Error ratio for coherent PHY types

Draft 1.4 comments 16, 115, 117, 118

Matt Brown, Alphawave Semi

Figure 184-2—Inner FEC functional block diagram

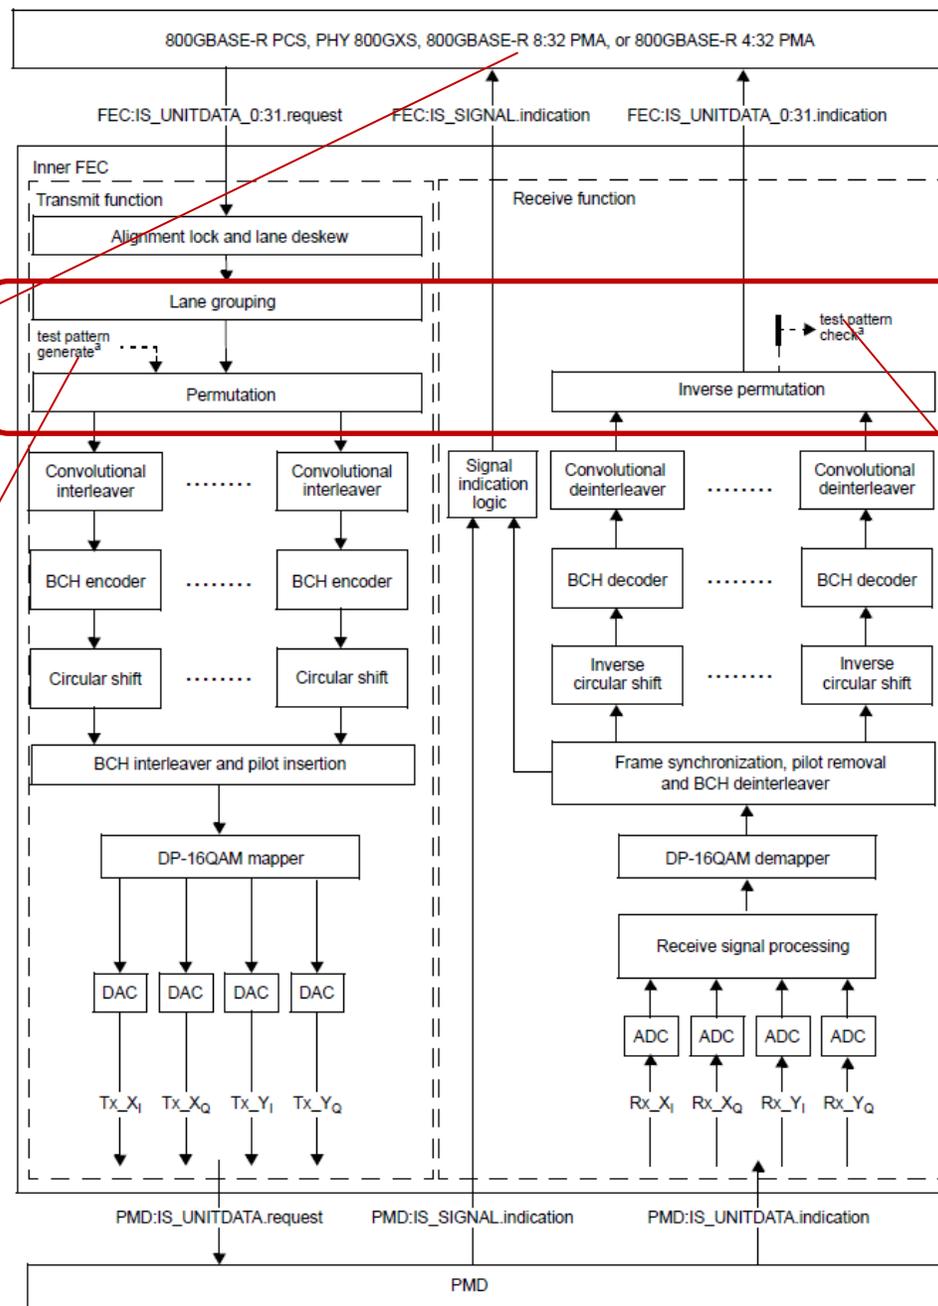
Other comments propose that with the addition of the PRBS31 generator and checker in the 800GBASE-LR1 Inner FEC it is now possible to assess the quality detected signal using block error counters similar to the method for PAM4 PMDs and AUIs as defined in 174A.7.1.

For this Inner FEC, the interface to the sublayer above is 32 PCS lanes, i.e., not one lane per PMD lane. Implement block error counters on the PMA would require 32 instances and they'd all have to be convolved together.

Single PRBS31 pattern generator here

The pattern from a single generator is round-robin distributed to each of the 32 FEC flows.

Single PRBS31 pattern checker here

The pattern from 32 FEC flows is reassembled then processed by the checker.

Corresponds well to the single optical lane.

Update the specification for a PMD receiver in 185.2 accordingly.
Provide test configuration and method in 174A.
A contribution will be provided.

Figure 174A-X—Test configuration for 800GBASE-LR1 PMD

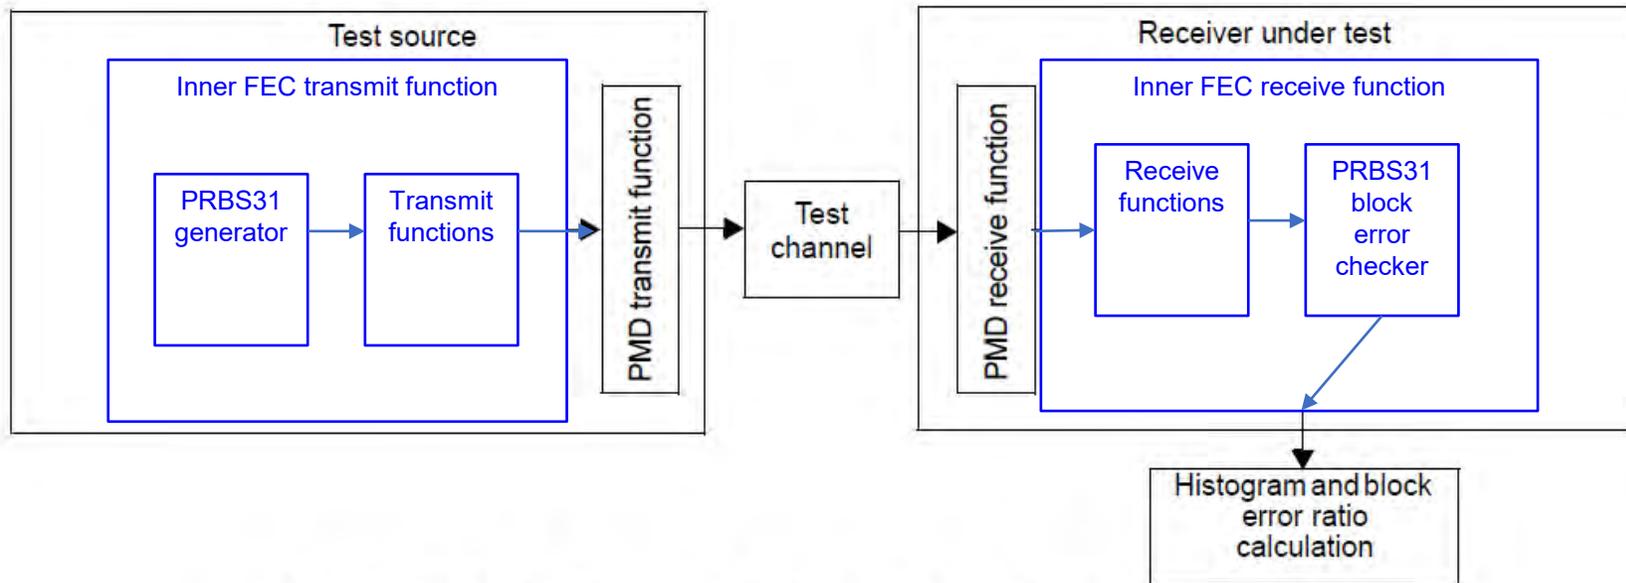
Add new test configuration diagram in 174A.x.1.1

Draft 1.4 error ratio allocations for 800GBASE-ER1/ER1-20 Physical Layer Implementations

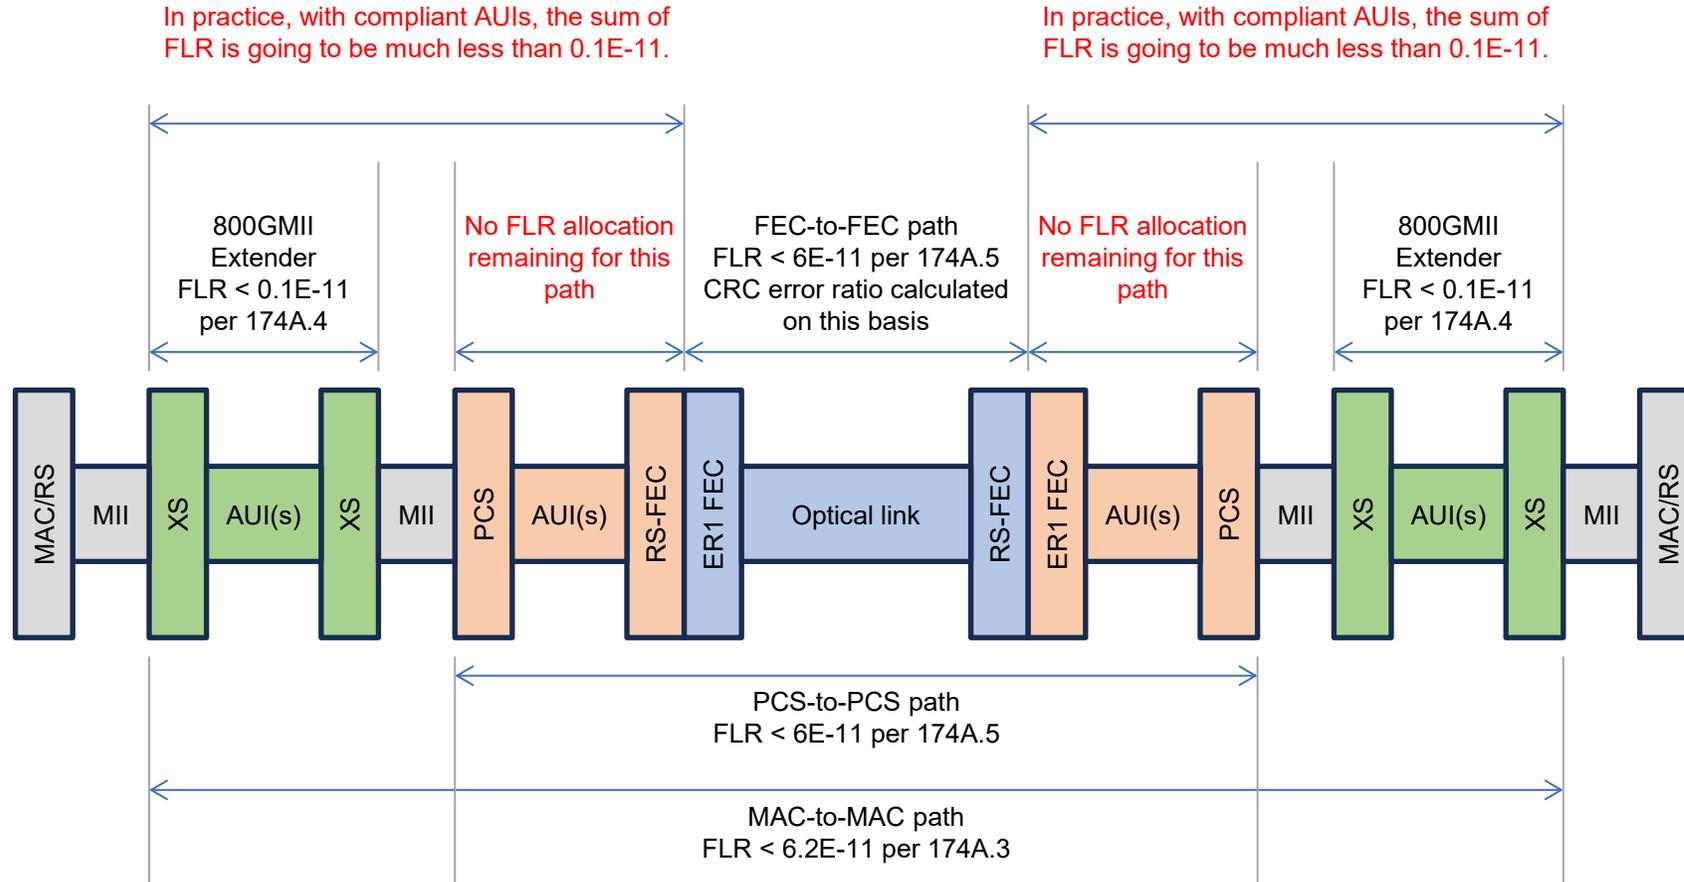
CI 174A	SC 174A.6	P 662	L 31	# 16
Brown, Matt		Alphawave Semi		
Comment Type	T	Comment Status	X	
CRC error ratio based on 6E-11. However, this would not account for an Extender plus a pair of AUIs in the PHY. Options:				
(a) disallow extender				
(b) state that either extender or AUIs in PHY, but not both				
(c) reduced FLR for PCS-to-PCS to 5.8E-11.				
<i>SuggestedRemedy</i>				
A contribution will be provided.				
Proposed Response		Response Status	O

Not accurate. This table is for optical PHYs with concatenated Inner FEC. This table does not apply to optical PHYs with a segmented FEC, like 800GBASE-ER1/ER1-20.

There is ample margin in the xMII extender budget that might be shared between the xMII extender and the RS-FEC to RS-FEC path on the PHY.

Option #4: add a note that the FLR allocation for the xMII Extender can be shared with the RS-FEC path

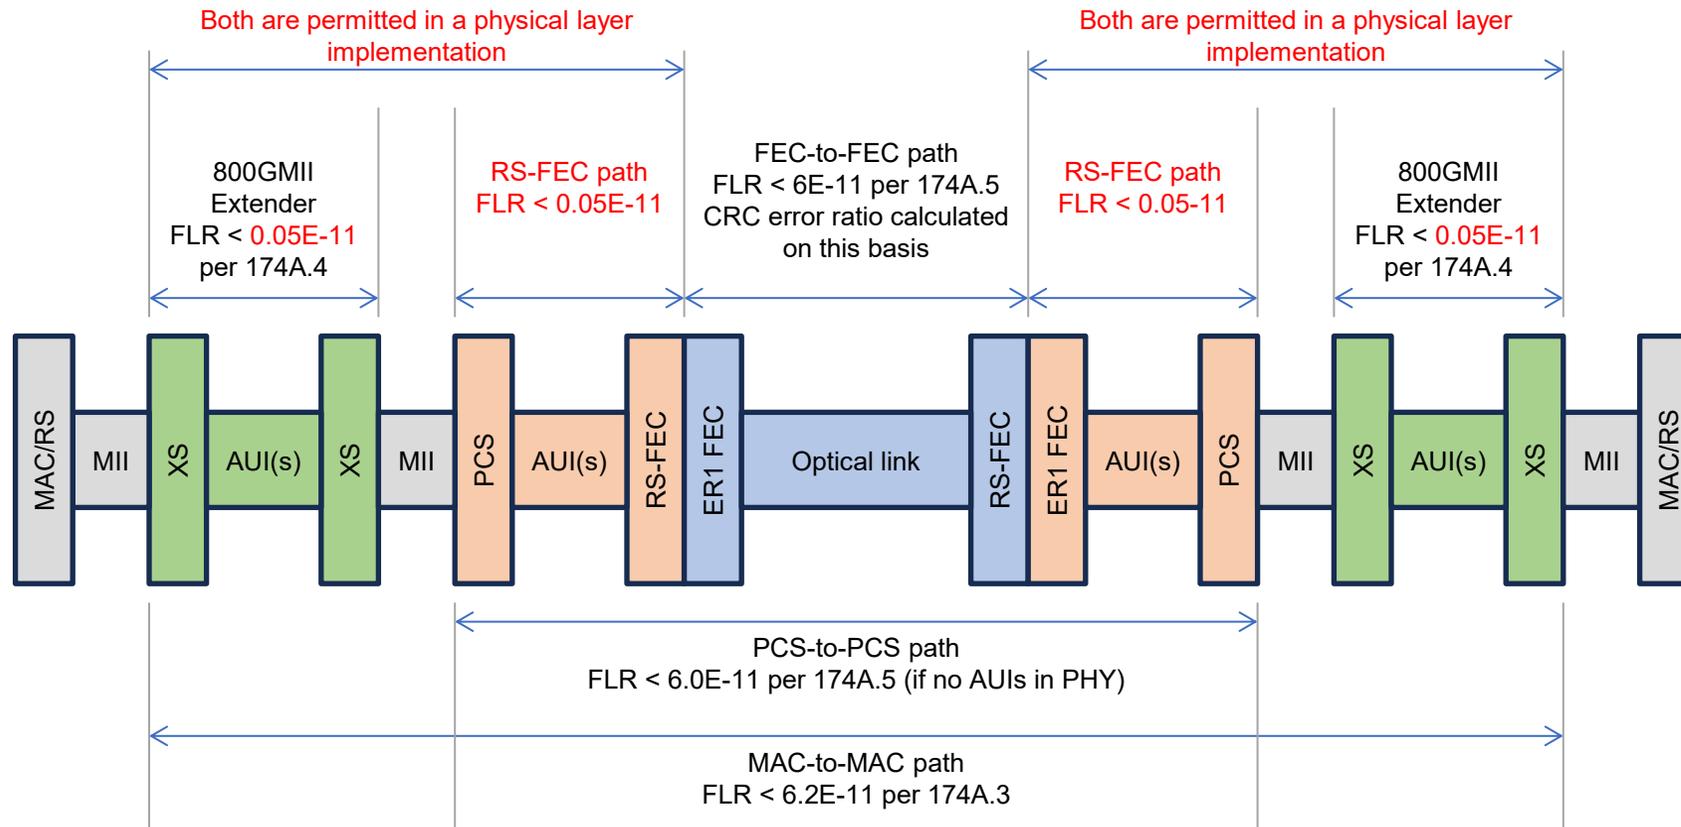
For random BER of 0.34E-4, FLR of 2.5E-25 can be supported on each path. Therefore in practice, with compliant AUIs, the sum of FLR for the xMII Extender and the RS-FEC path will be far below 0.1E-11.

(d) leave allocations as they are but add a note pointing out that the sum of FLR for the xMII Extender plus the RS-FEC path are unlikely to exceed the allocation for the xMII Extender of 0.1E-11 if compliant AUIs are used.
